**project.** Sherwood Library Renovation | 1225 Wonderland Rd N, London, ON

**project no.** 23-006

This Addendum is issued before the award of Contract to inform the Contractor of certain modifications to the work described in the Drawings and Specifications dated September 18, 2024.

end of addendum | 001

ICC-202 Scale: 1/2" = 1'-0"

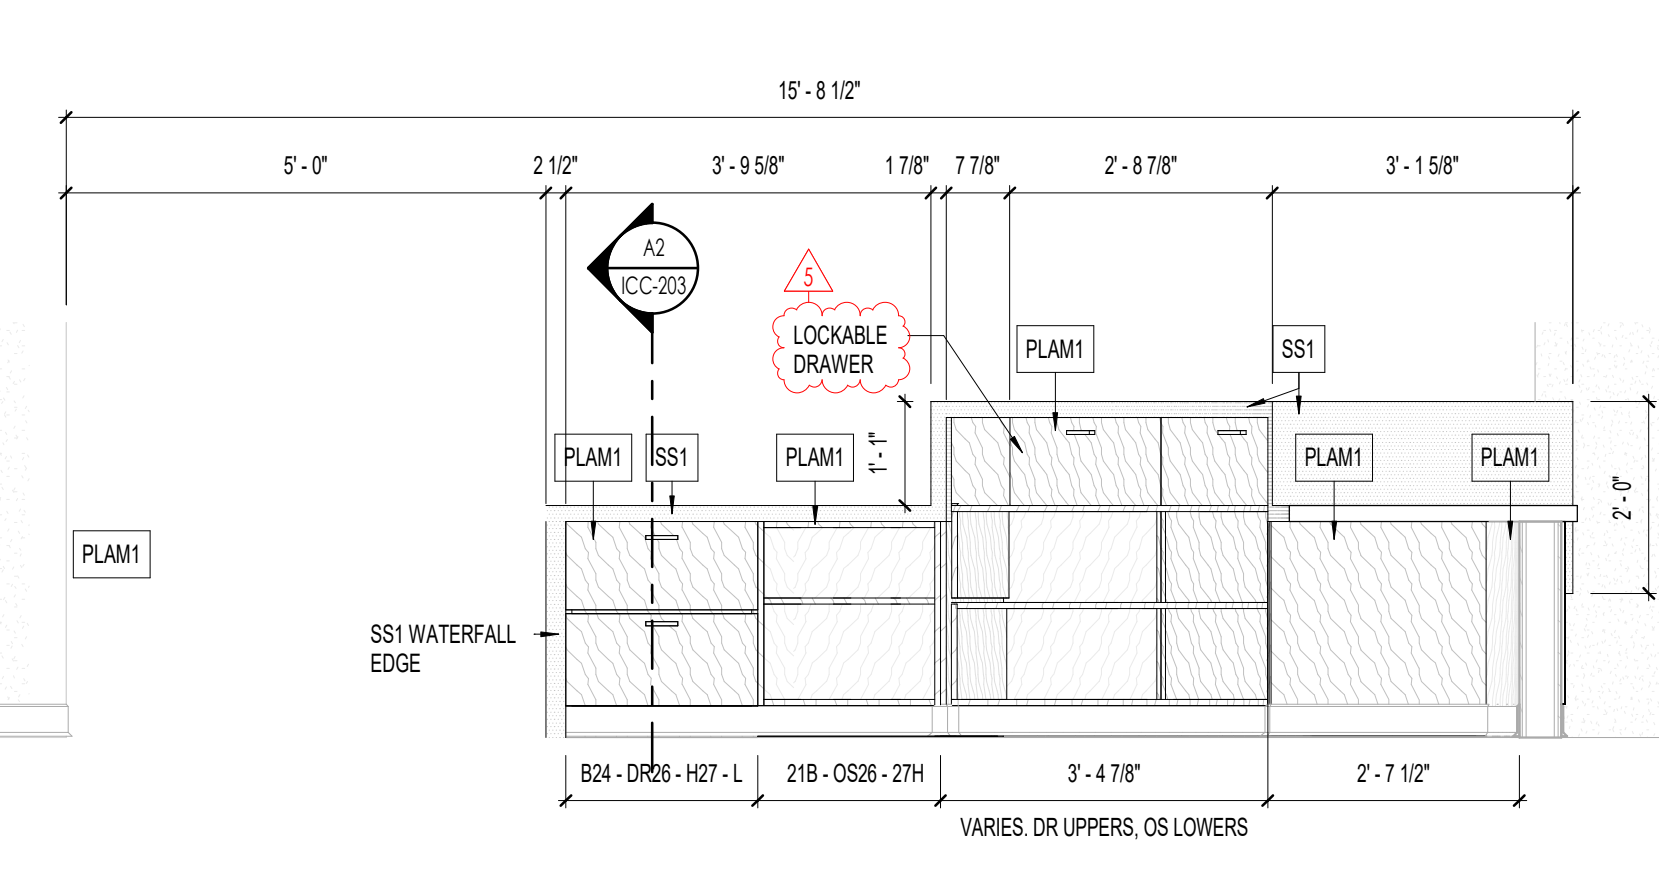
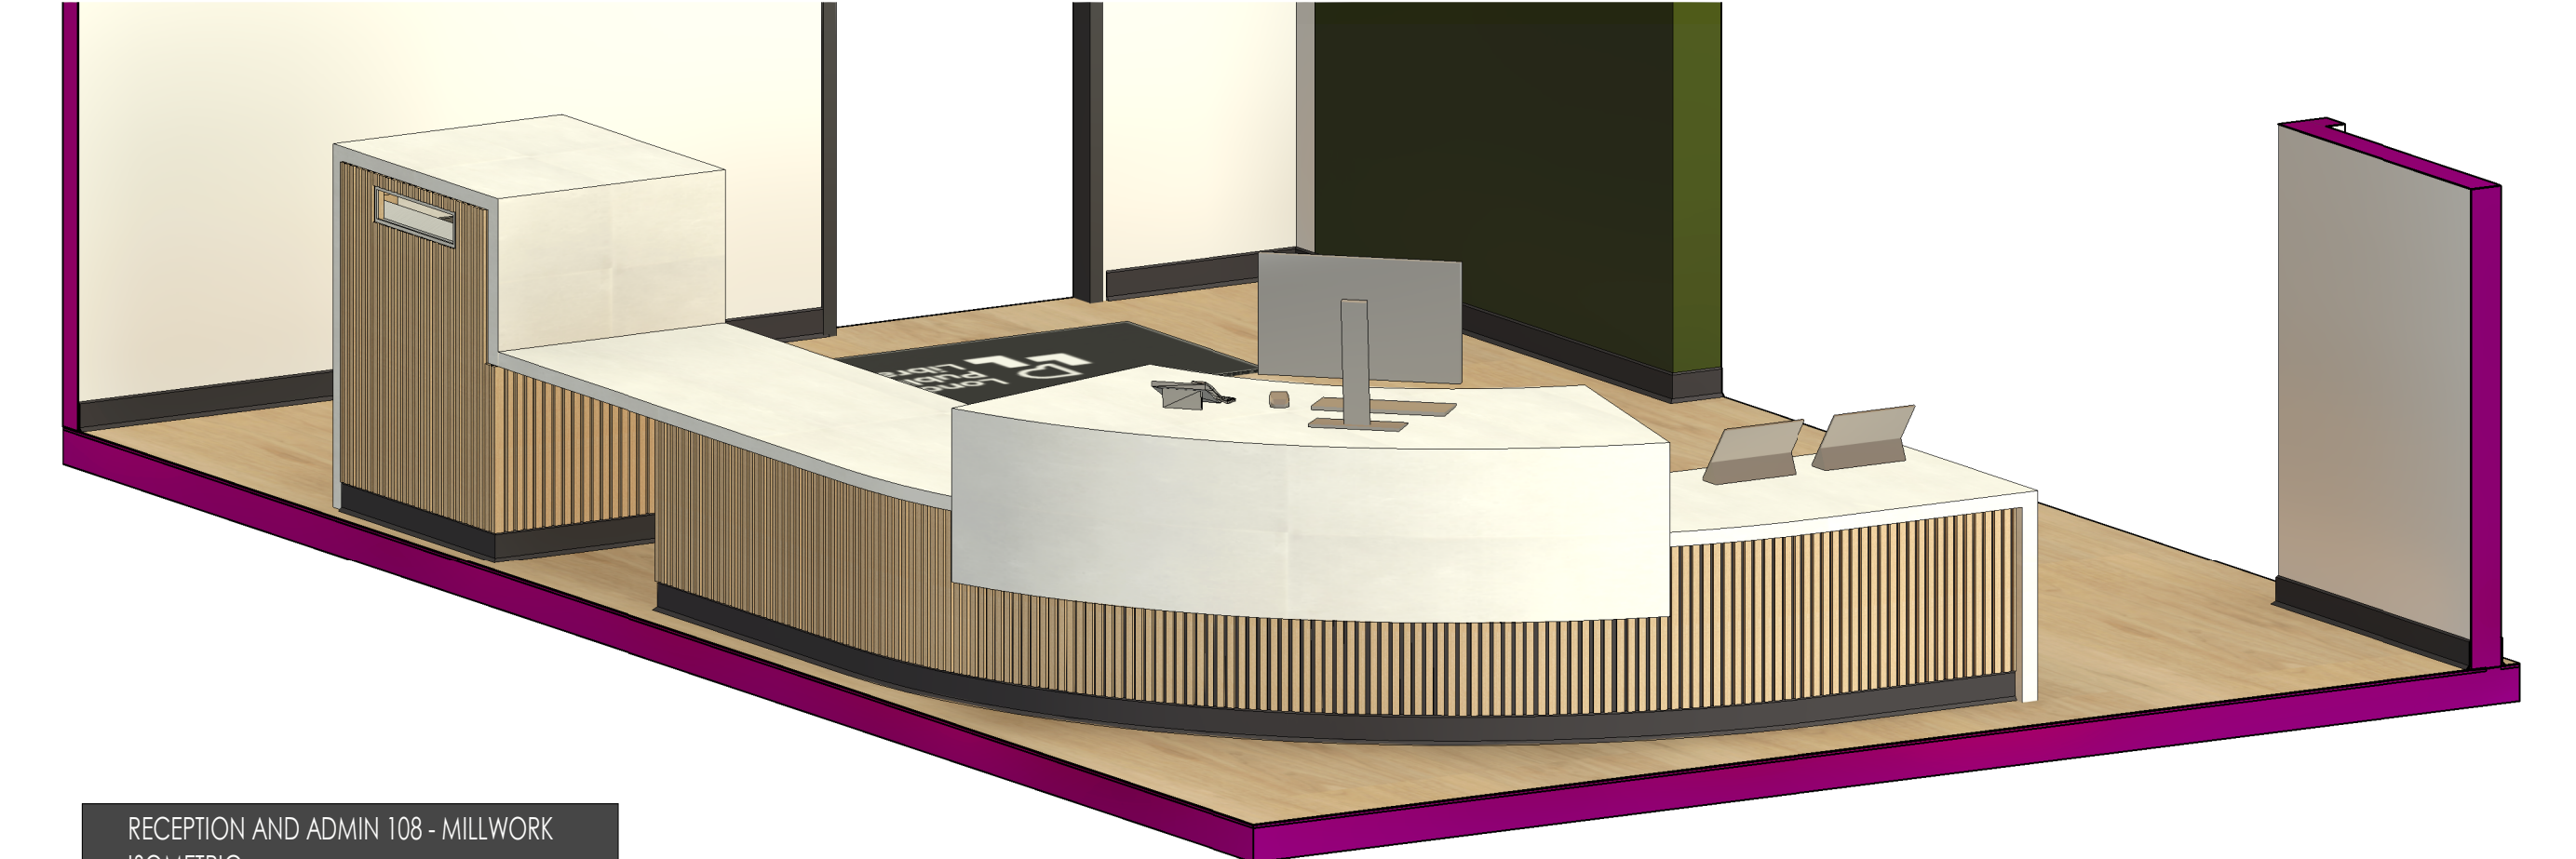
3.4 ICC-202 MILLWORK PLANS & ELEVATIONS

Refer to attached ICC-202.  
**Revise location of lockable drawer location at the reception/admin desk as follows:**
